Re: IR 50-423/94-21

Millstone Nuclear Power Station, Unit No. 3
Response to Inspection Report 50-423/94-21
Erosion of Cement from the Millstone Unit No. 3 Containment Mat

Millstone Nuclear Power Station, Unit No. 3
Erosion of Cement from the Containment Mat

FIGURE 3.8-24 (1 OF 3)
 DETAIL OF RING GIRDER AT
 ESF BUILDING
 MILLSTONE NUCLEAR POWER STATION
 UNIT 3
 FINAL SAFETY ANALYSIS REPORT

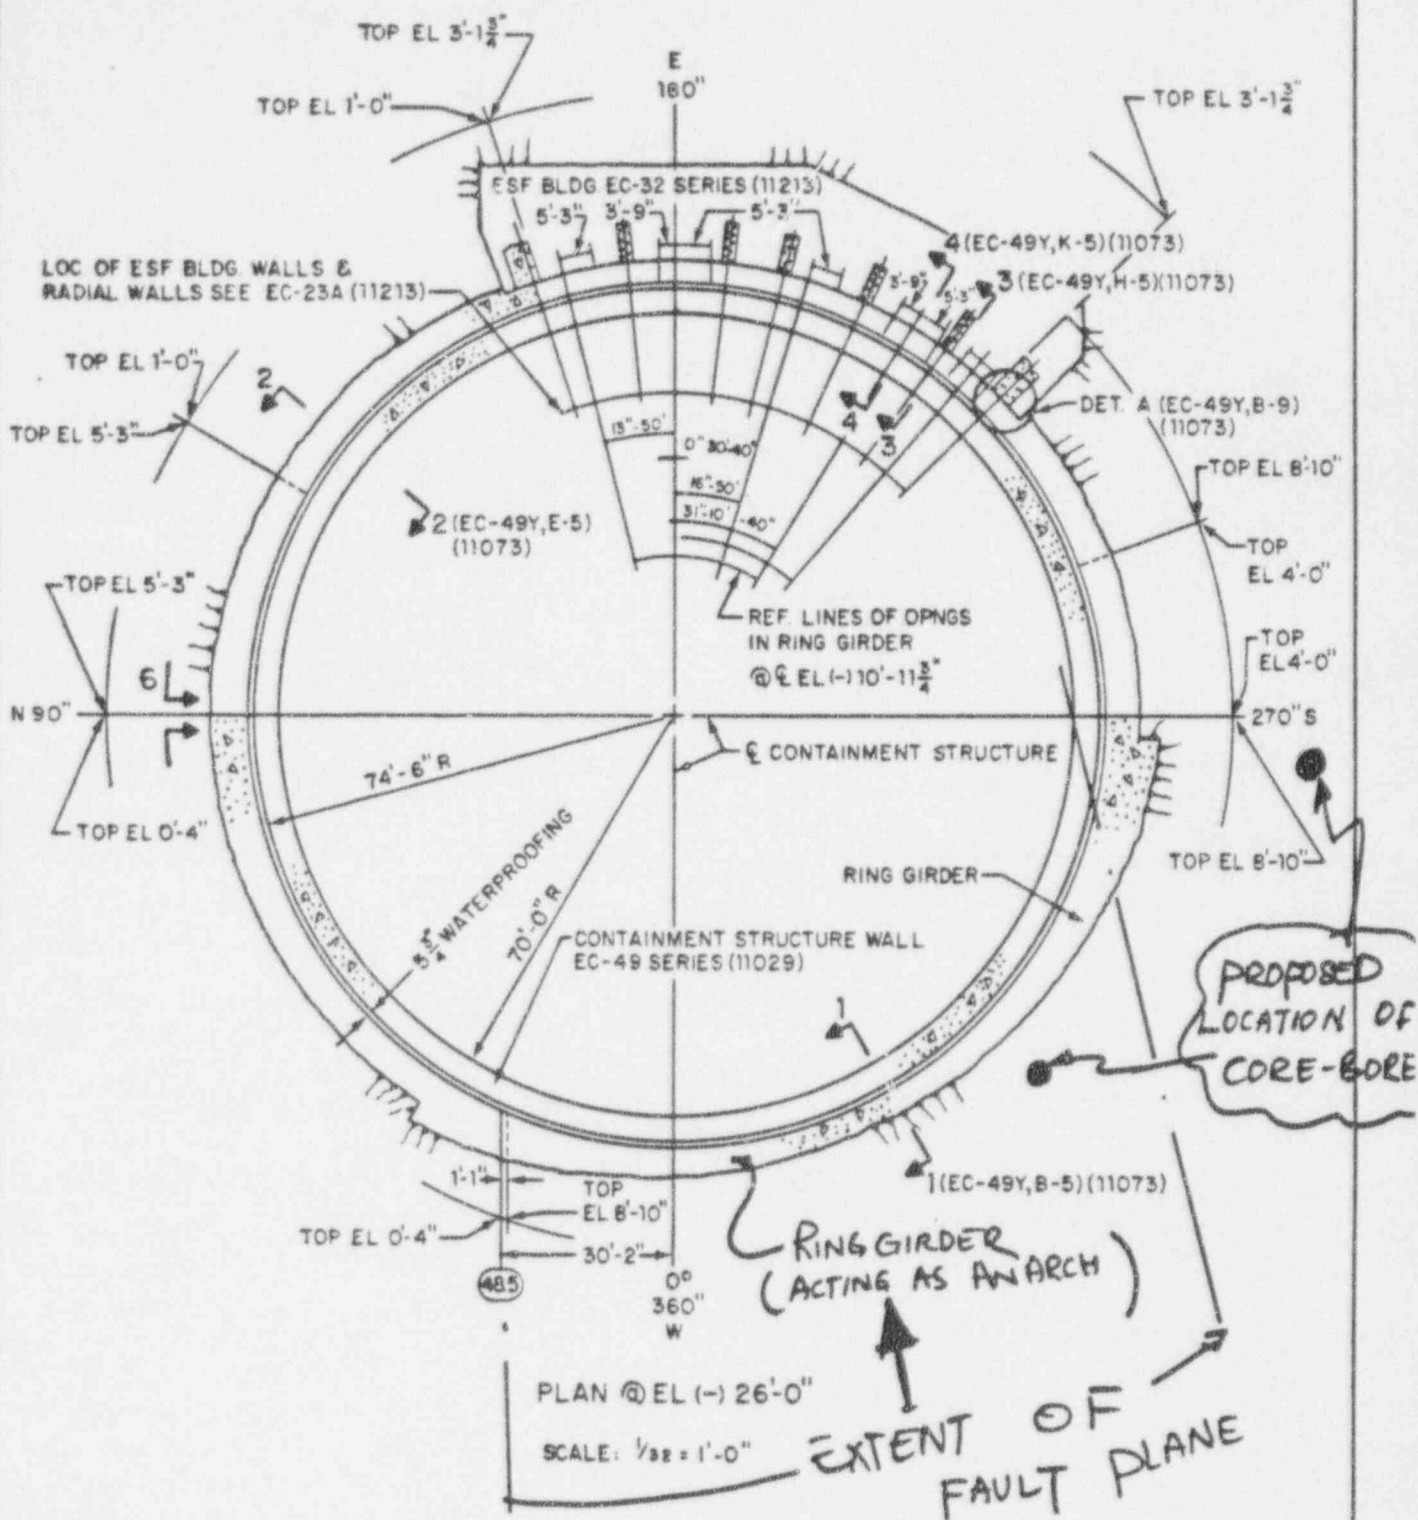
Item #3 The effect of high/low tides in the Long Island Sound on the drainage/seepage under the containment should be evaluated.

Audit Item #3 Enclosed Fig. 3.8-24 (1 of 3), detail of ring girder at ESF Building -is extracted from MP3 FSAR Section 3.8. The ring girder, encompassing from South to Column Line 48.5 passing West, represents the portion of the ring beam which acts as an arch in preventing the rock from sliding at the seismic fault plane impacting onto the containment wall. The pore water pressure impinging on the containment mat due to Long Island Sound tidal variations may infiltrate through the fault plan to the underside of the containment mat.

In order to address this issue, NNECO will evaluate the feasibility of drilling two 4" diameter holes, one close to the containment wall and another in the general area of the containment. These bore holes act as piezometers and would help to determine the water levels, which would then be reviewed periodically.

The bore hole close to the containment, will be drilled to EL (-) 40'-0" passing through the fault plane and stop just below the porous concrete media. This facilitates the study of the possible influence of pore-water pressure due to Long Island Sound tidal variations.

The second bore will be limited to the top of the bedrock. The purpose of this hole would be to measure the water table in the structural fill due to rainstorm surface run-off. In addition to quantifying inflow of

FIG. III-1

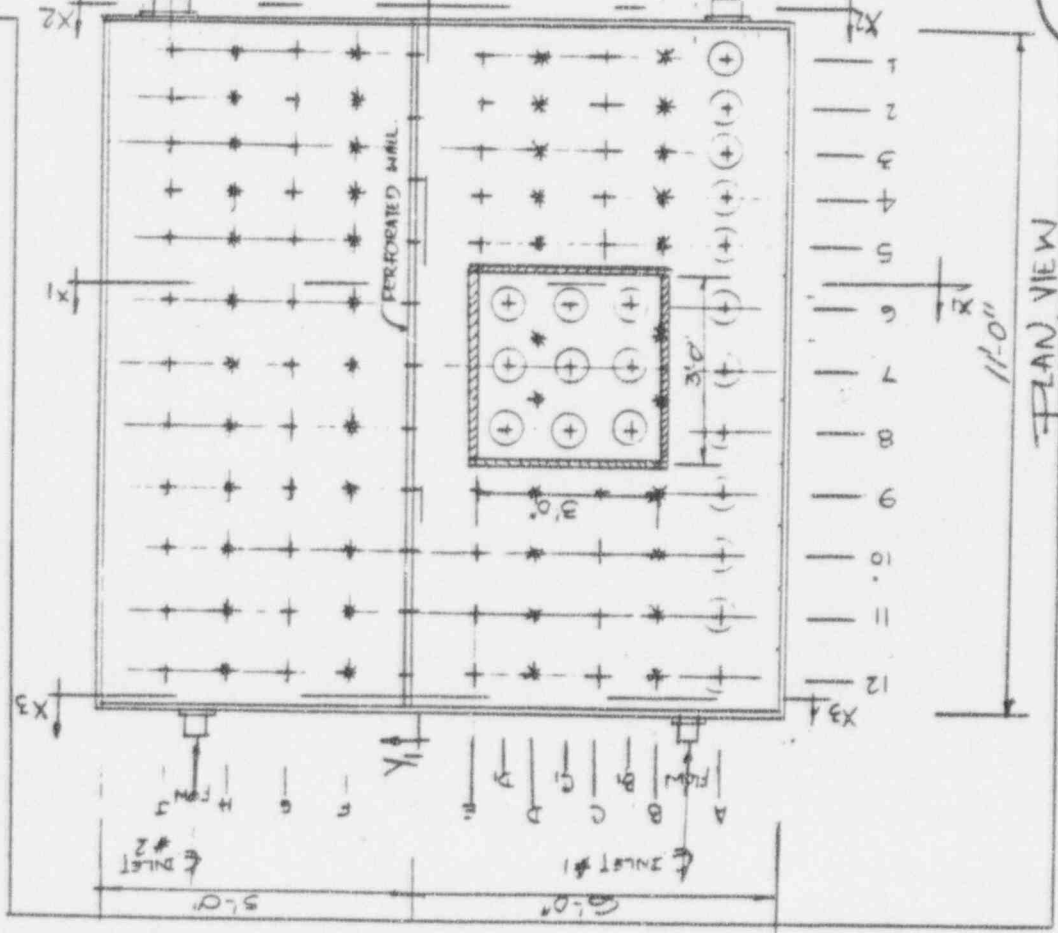
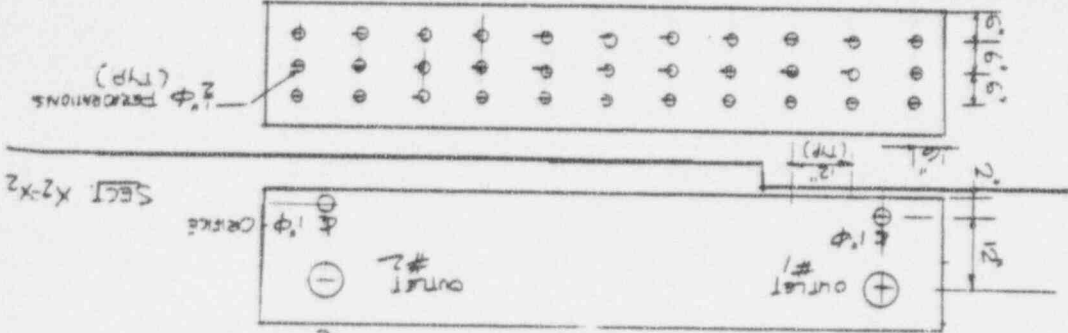
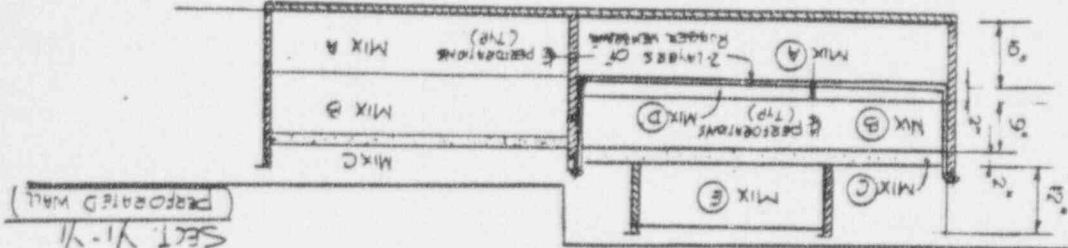
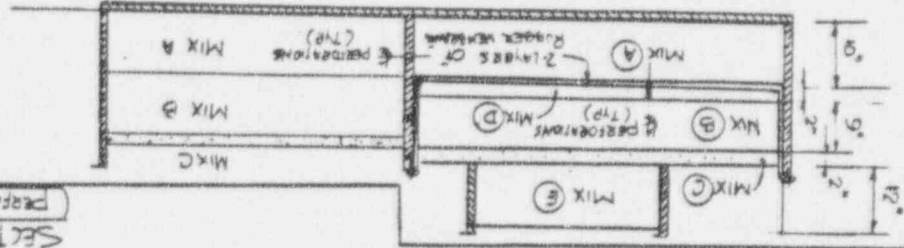
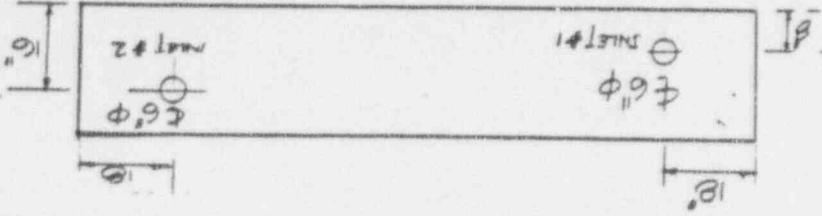
- Item #1 The test and evaluation of the interface between the high Alumina Cement in the porous concrete and the Portland Cement in the Containment Basemat has not yet been completed;
- Item #2 Dynamic behavior of the containment structure during seismic events should be evaluated. This evaluation should address the high pore pressure because of the clogged drainage system, the changes in normal

Audit Item #1 Enclosed Figure III-1 represents the proposed Phase III mock-up test mold. It measures 11'0" by 11'0" divided into two chambers. The first (11'0" by 6'0") will be used to model the porous concrete to simulate the "as-built" construction of the containment foundation substructure. The second (11'0" by 5'0") will be constructed within the intermediate membrane and 1" thick seal mortar.

1. Evaluate the potential chemical reaction between the high alumina cement and the Portland Cement structural concrete. Not only the bond strength at the interface plane of the two cements will be observed, but also the compressive strength will be assessed to determine if any loss of strength has occurred when compared to the strength of the samples cored out from the sister mold, fig. III-2.

2. Address the long term effects of the water flow on the concrete by conducting a series of compressive tests of the core samples for a duration of 6-12 months. During this period the flow of water will be regulated to simulate water porosity through two 6" diameter inlet nozzles to a rated flow provided by least a foot head of water. Intermittent flow of water will also be introduced to represent the no-flow in-leakage condition. In addition to the above, reverse flow of water will also be performed
